Letter: **YS-003-2018**

Subject: **Split system performance issue resolution for indoor coils installed in Horizontal right and down-flow applications.**

Product: CF/CM/60C, CF/CM60D, AP60C, AP60D, AE60C, AVC60C, RFCX60CP, RFCX60DP, RFCX60CE

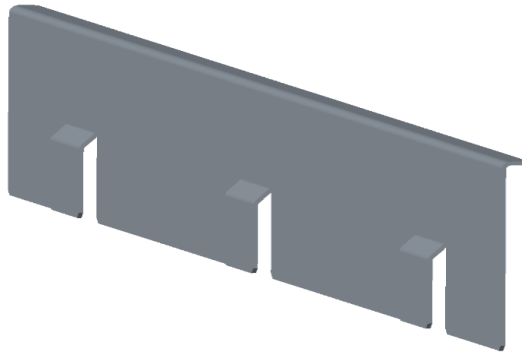
As with all Max-Alloy aluminum “N” coils, the only orientation that required the installation of additional condensate management parts is horizontal right applications. A set of condensate deflectors are included with every air handling unit and CM model indoor coil. These parts are quickly and easily installed between the indoor coil primary drain pan and delta plates when a coil will be applied in the horizontal right orientation. Both the front and rear condensate deflectors were the same part. The new 60C and 60D coil design still use a set of condensate deflectors, but the design of the **60C** deflectors has been modified. With the redesigned **60C** coil there are separate front and rear condensate deflectors. The front and rear condensate deflectors must still be installed for horizontal right applications. The difference in the redesigned **60C** condensate deflectors is there is one part specifically for the rear of the coil and one part is specifically for the front of the coil. An image of the 60C condensate deflectors is shown below.

The new re-designed 60D coil will continue to use the same condensate deflectors as currently supplied with the 60D coil (CM60D) and air handlers containing the 60D coil (AP60D, RFCX60DP.)

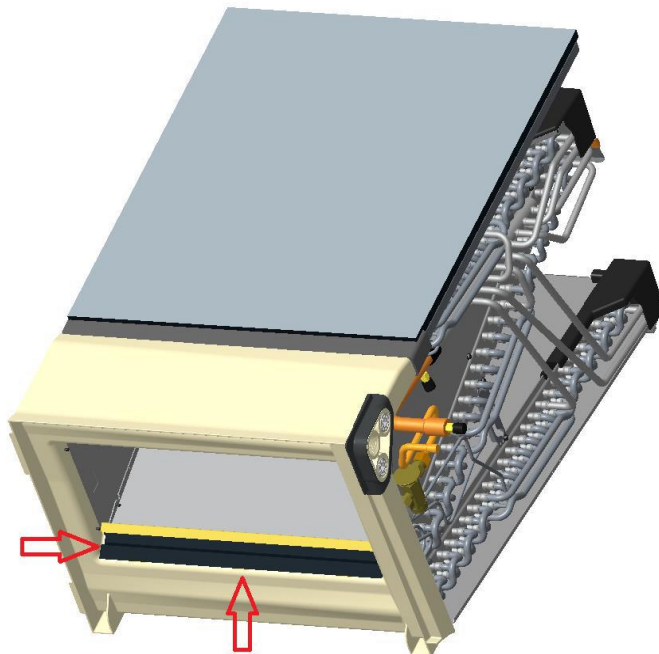
In addition to these two condensate deflectors, there is also a “condensate shield” that will be **FACTORY INSTALLED** on the coil primary drain pan right hand side. An image of this new part is shown below.

This condensate shield is placed on the primary drain pan and is sealed to the coil drain pan with an adhesive backed gasket strip. An image of the coil assembly with this new factory installed part is shown below. The arrows point to the factory installed condensate shield.

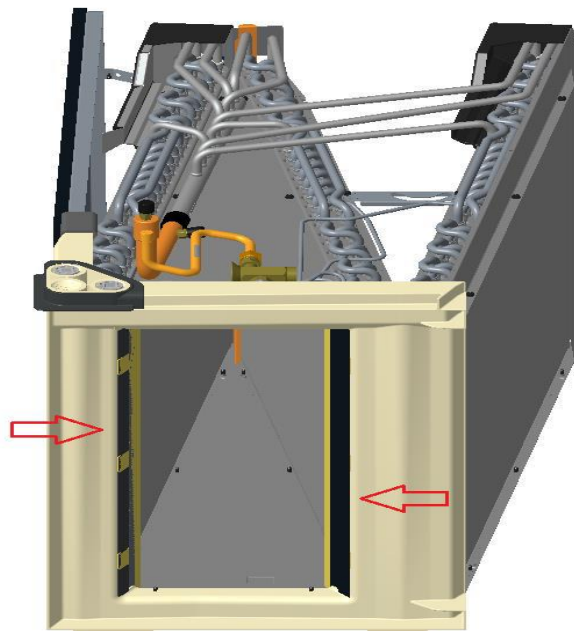
If the coil is to be applied in a down-flow orientation an additional condensate shield must be field installed onto the opposite side of the primary coil drain pan in a “mirror image” fashion from the image shown above. This part installation would take place while the coil is removed from the unit for down-flow conversion in air handling applications. For split system cased coil applications, the coil does not need to be removed from the coil cabinet to install the condensate shield. Simply rotate the coil cabinet so that the bottom of the coil primary drain pan can be accessed. The condensate shield can then be easily added to the bottom of the primary drain pan and sealed with the supplied adhesive backed gasket material. An image of both condensate shields installed on a coil for use in a down-flow application is shown below. The arrows point to the condensate shields. Note that the left side field installed condensate shield has not yet been sealed to the primary coil drain pan, therefore, the 3 shield attachment tabs are showing.
